**La Jolla Shores Planned District Advisory Board (LJSPDAB)
APPLICANT PROJECT INFORMATION FORM**

- Project Tracking System (PTS) Number/Accela "PRJ" Number and Project Name (only submitted projects to the Development Services Department can be heard as action items):
PRJ-1085883

- Project description:
 - **SITE DEVELOPMENT/COASTAL DEVELOPMENT/NEIGHBORHOOD DEVELOPMENT PLANS**
 - 1 CONSOLIDATED LOT SPLIT INTO 6 INDIVIDUAL LOTS
 - EACH LOT TO CONSIST OF 1 SINGLE FAMILY DWELLING

TENTATIVE MAP NO. 3213966

Copyright W & F ARCHITECTS 2024
 LOT 3 NEW OPENING
 A:\Projects\2022\22071-01\CieloMar_Driving\Drawings\02-24-2023\CDP Submittal\A208.dwg

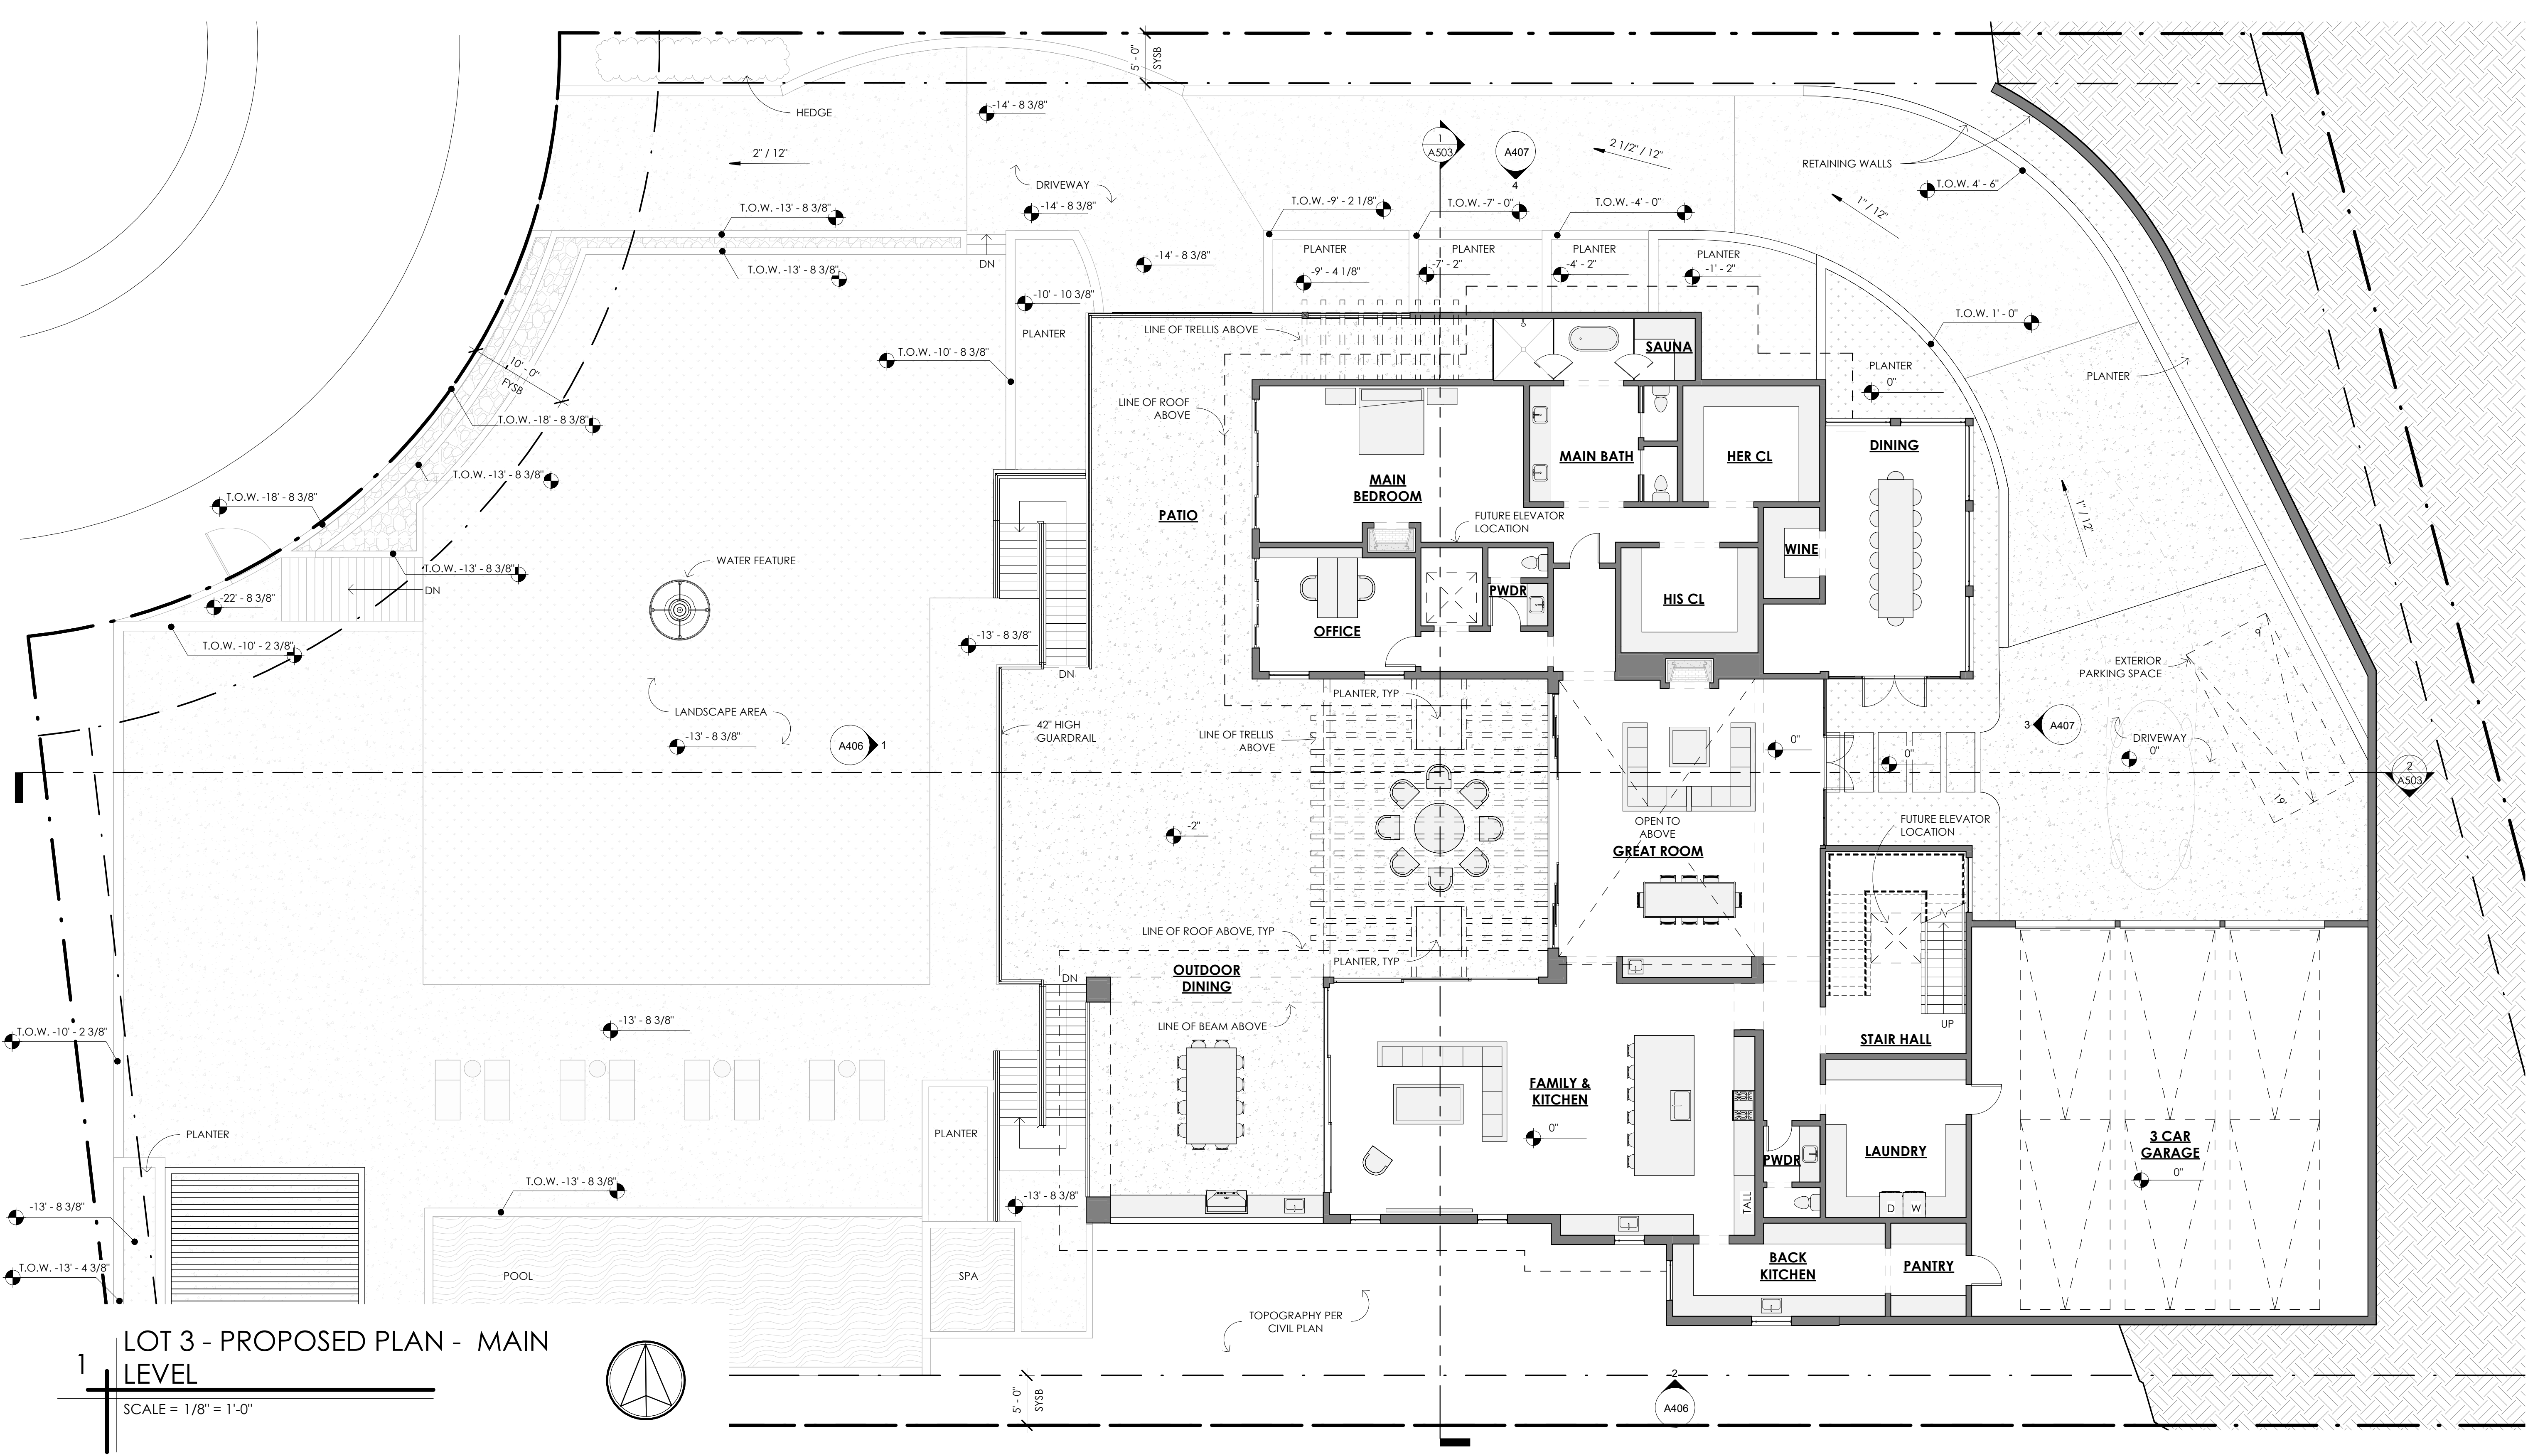
Per the applicant's response to Issues #103 and #201, the drive aisles for Lots 3 and 4 have been dimensioned on Sheets A000, A208, A209, and A214. However, the drive aisle widths are still not dimensioned for these lots. Please revise and dimension the drive aisle width for Lots 3 and 4 per SDMC Section 142.0521(e). Please note that a drive aisle is different from a driveway; a drive aisle is located within a project site. (3rd Request)

Sheet A208 shows 2 garage spaces in tandem; please clarify whether the rest of the lower garage will be for storage or any other use. Sheet A209 shows 1 surface parking space and 6 garage spaces in tandem configuration. It appears that the surface parking space would obstruct the parking spaces on the east side of the garage. Please demonstrate that vehicles can adequately maneuver in and out of these spaces through a turning template or remove the surface parking space from the plans and revise the parking count.

A219
LOT 6 - PROPOSED PLAN - LOWER LEVEL
06/21/2024

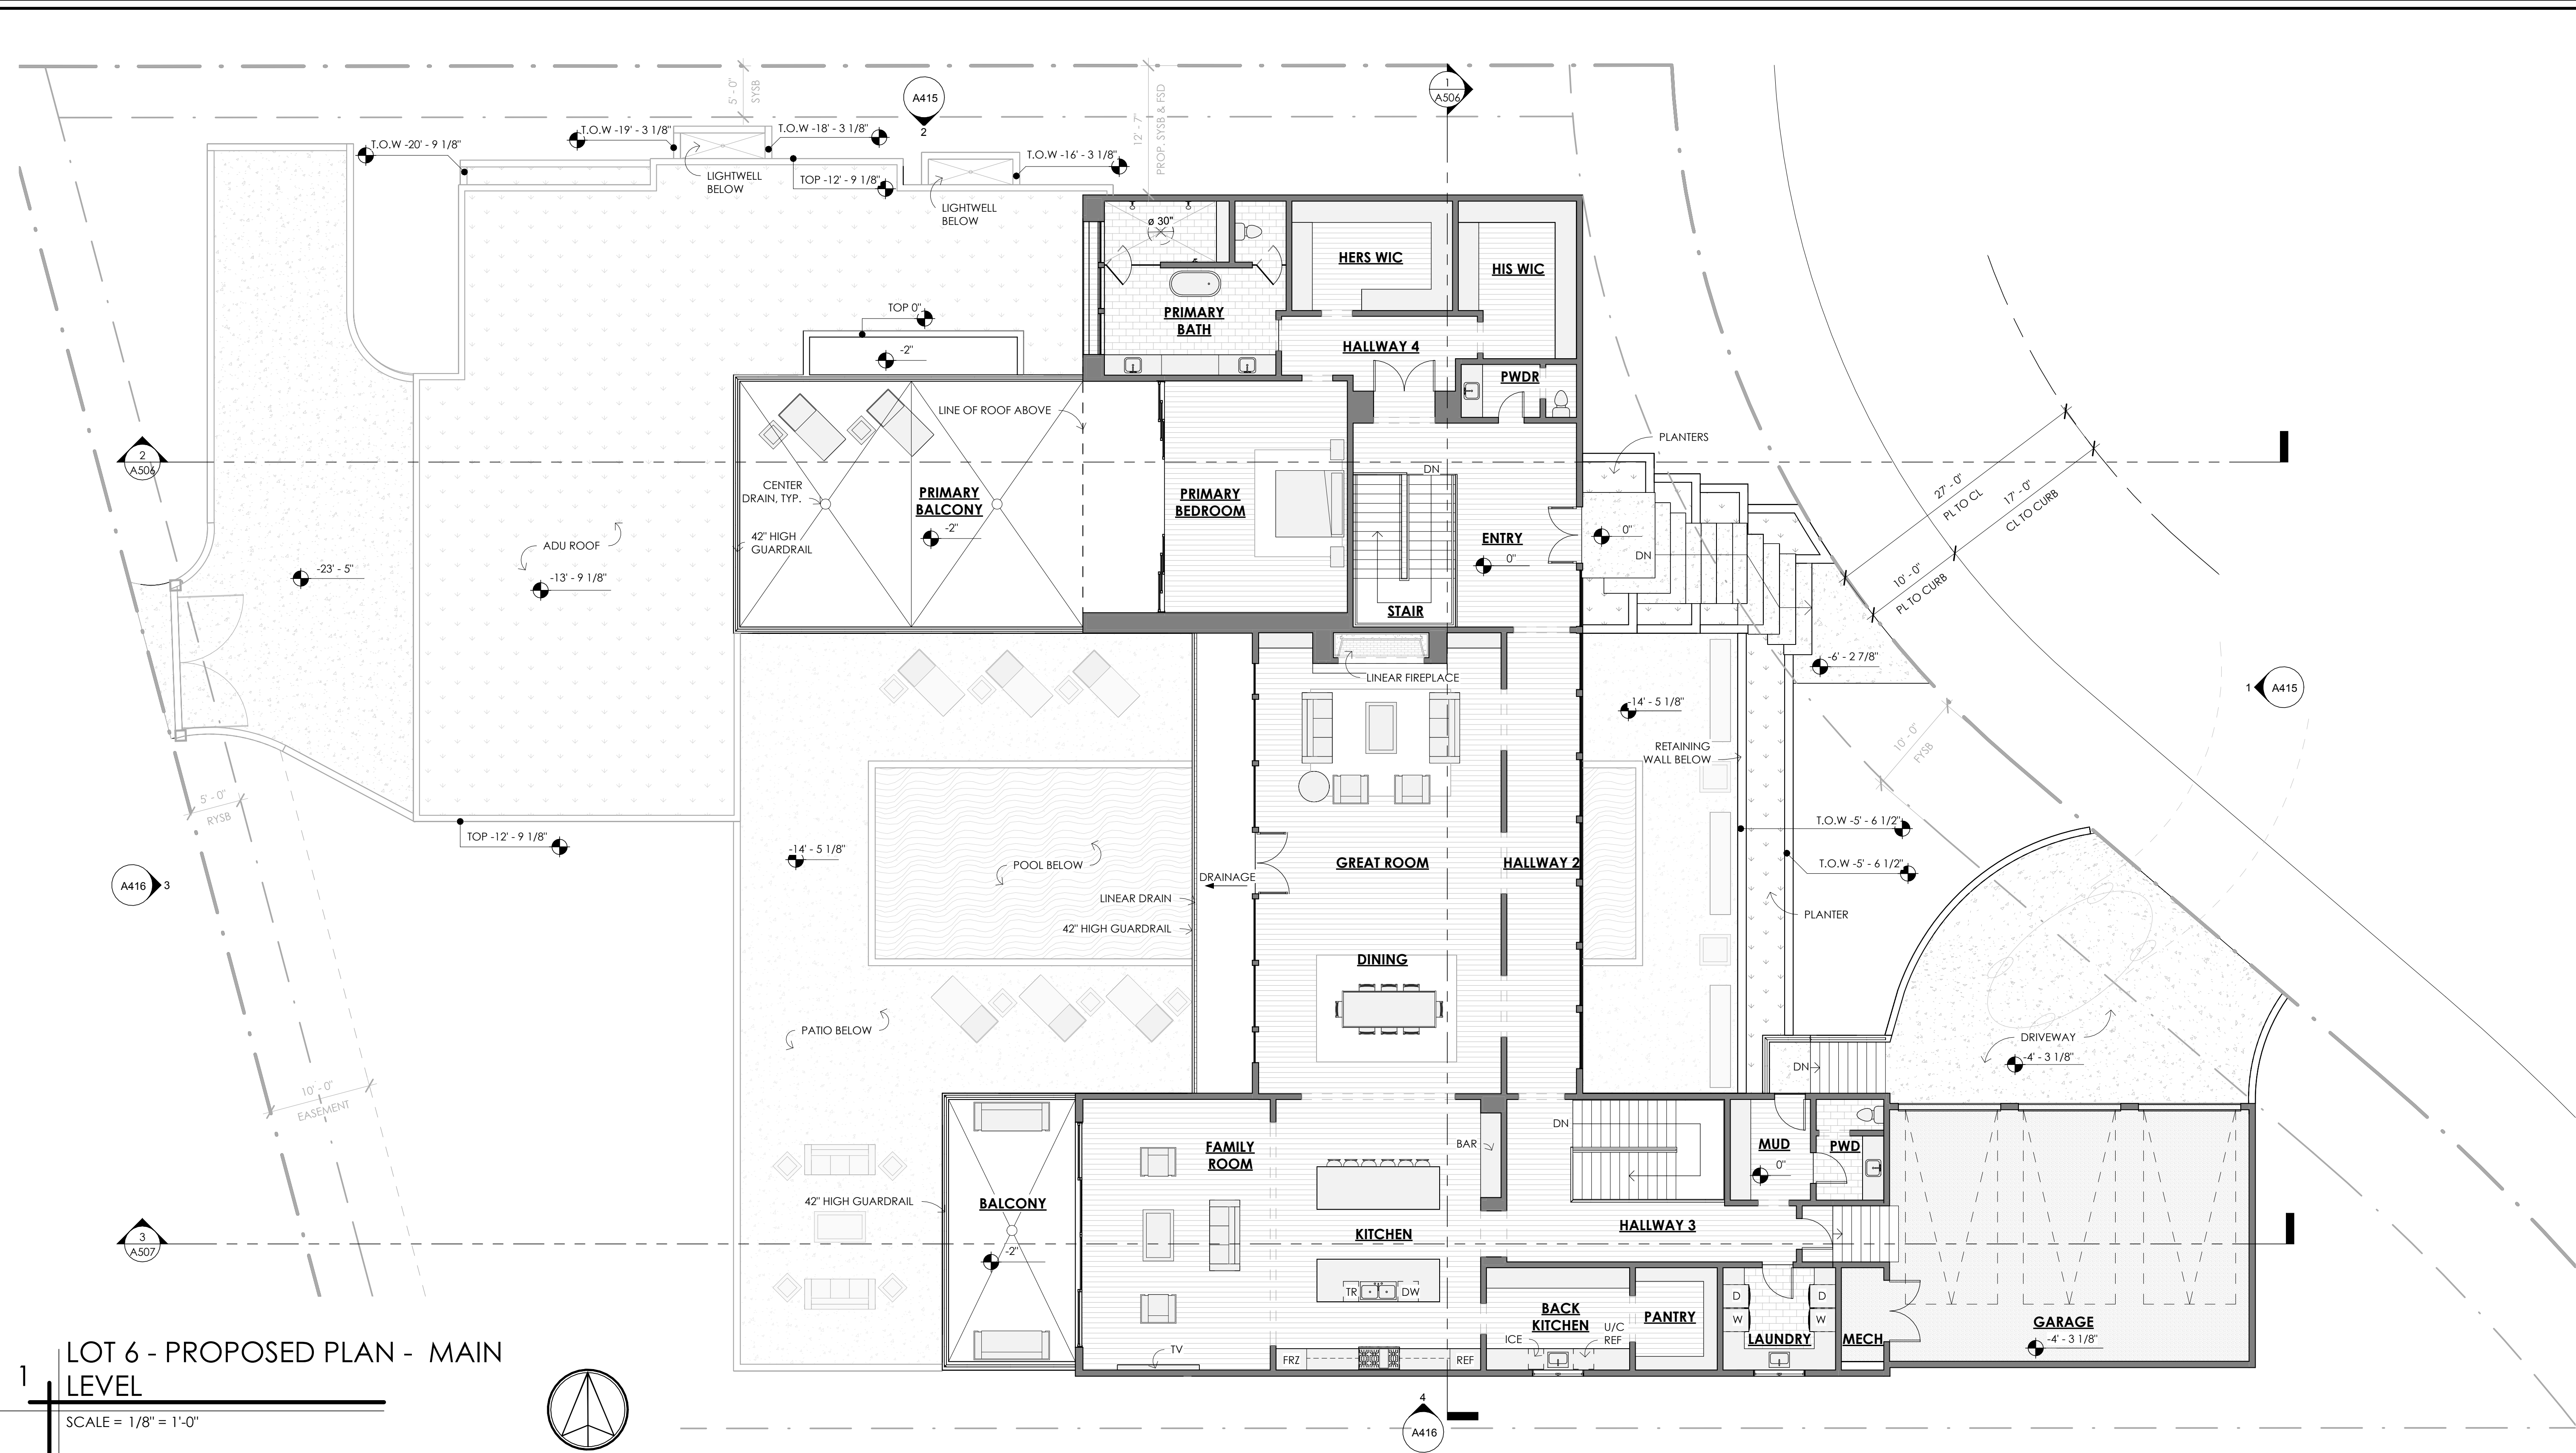
Sheet TS002 has been revised to show the correct number of parking provided. However, Sheets A001, A201, A204, A208, A209, A213, A215, A216, and A219 shows a total of 36 vehicular parking spaces, whereas the "Total Calculations For Development" on Sheet TS002 states 39 vehicular parking spaces. Please revise and correct this discrepancy.

A405
LOT 2 - EXTERIOR ELEVATIONS

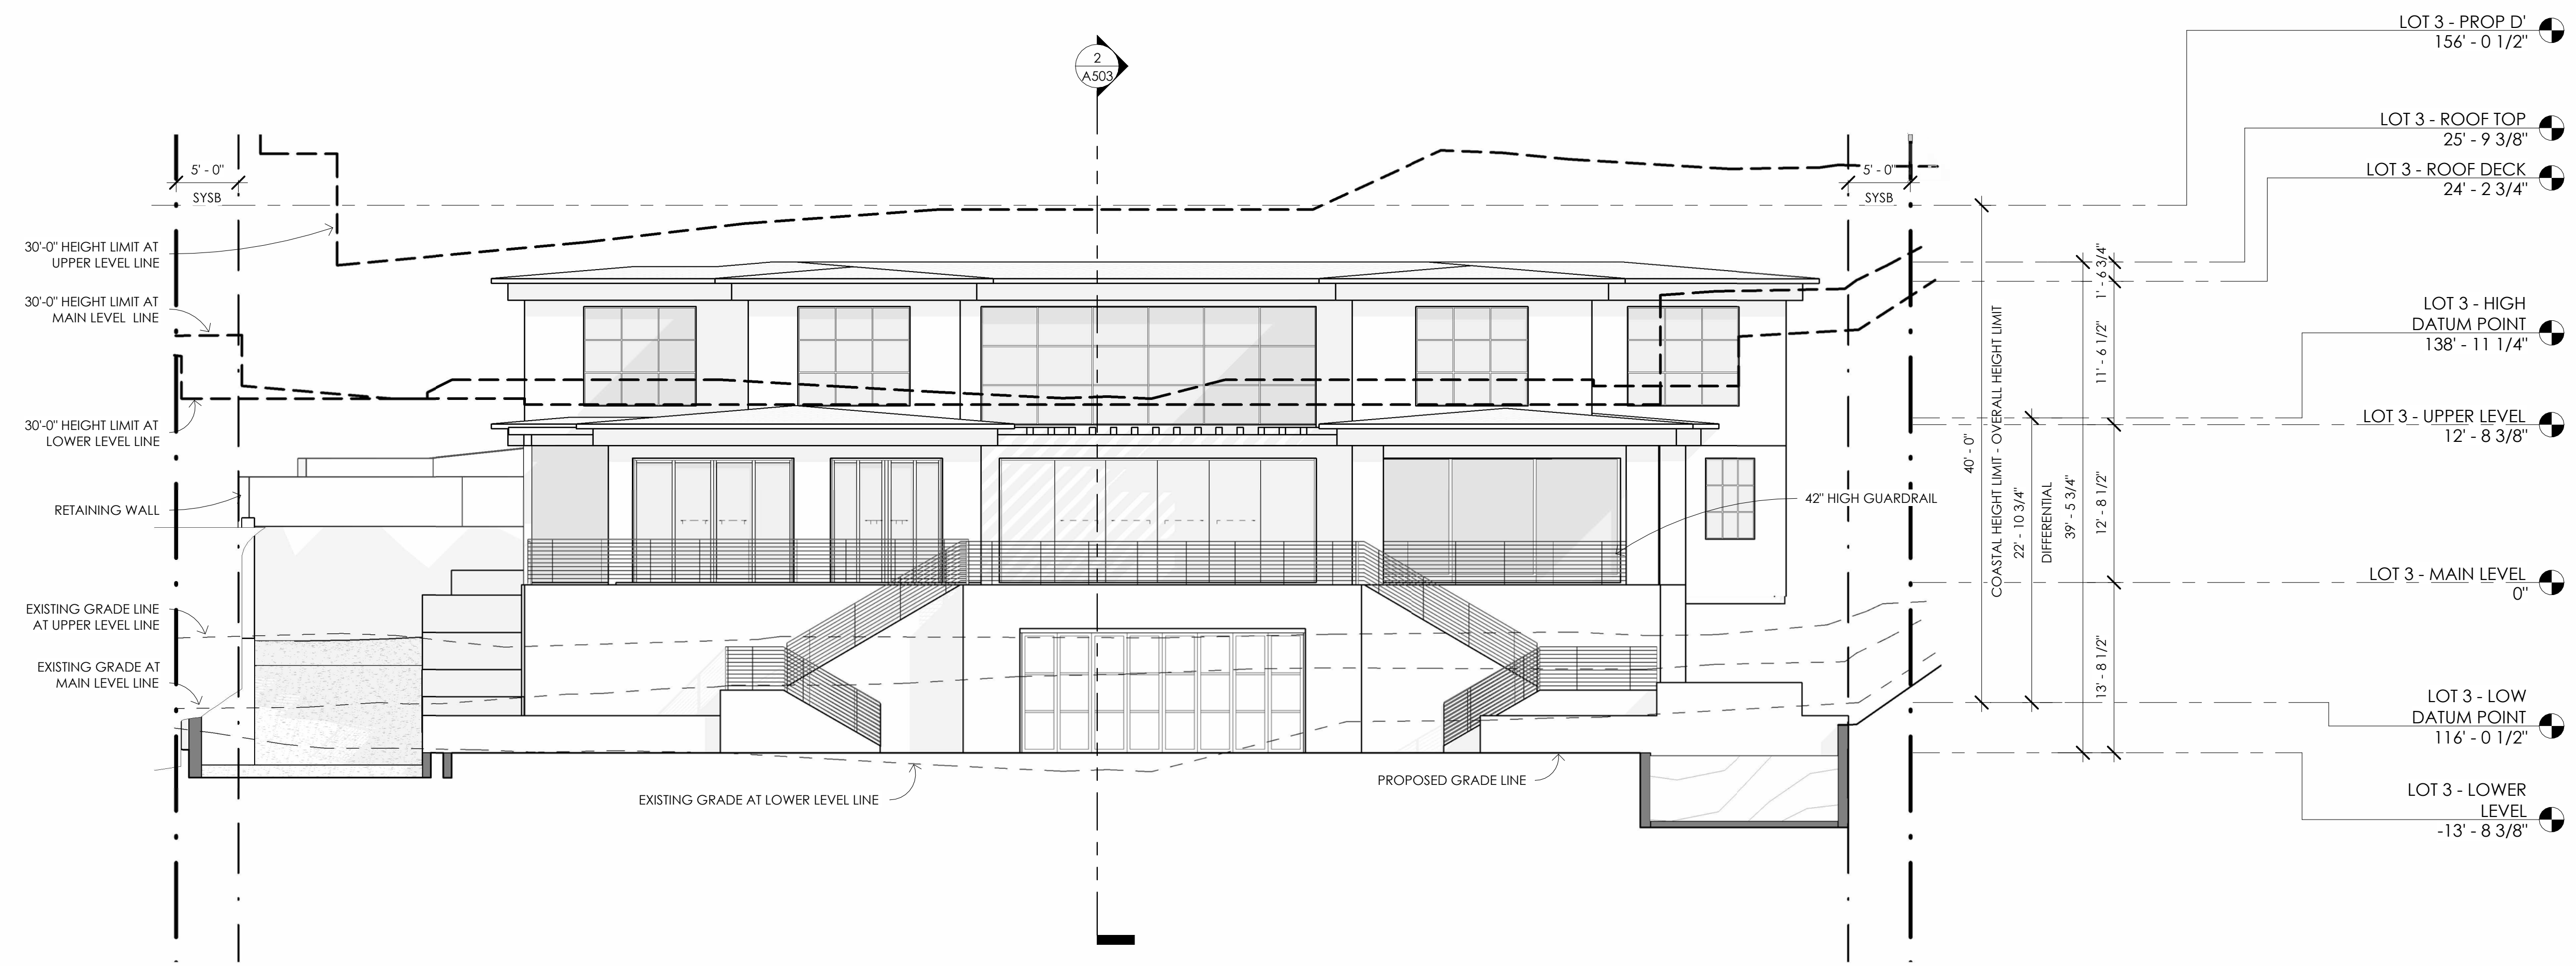
Sheet A 404 South Elevation – Section 2 – Unclear on the relationship with the finish grades on the site. It appears there are areas where the exposed grade is shown on the structure where an imaginary plane cannot be measured following 113.0270(4)

Per §113.0270(a)(2)(A), the existing grade on the elevations is not correctly presented. The elevations present a phantom grade (e.g., Lot 2 South Elevation Sec. 2 Sheet 404) that will no longer exist and should be measured parallel line to 30' unless special circumstances apply to each specific site.
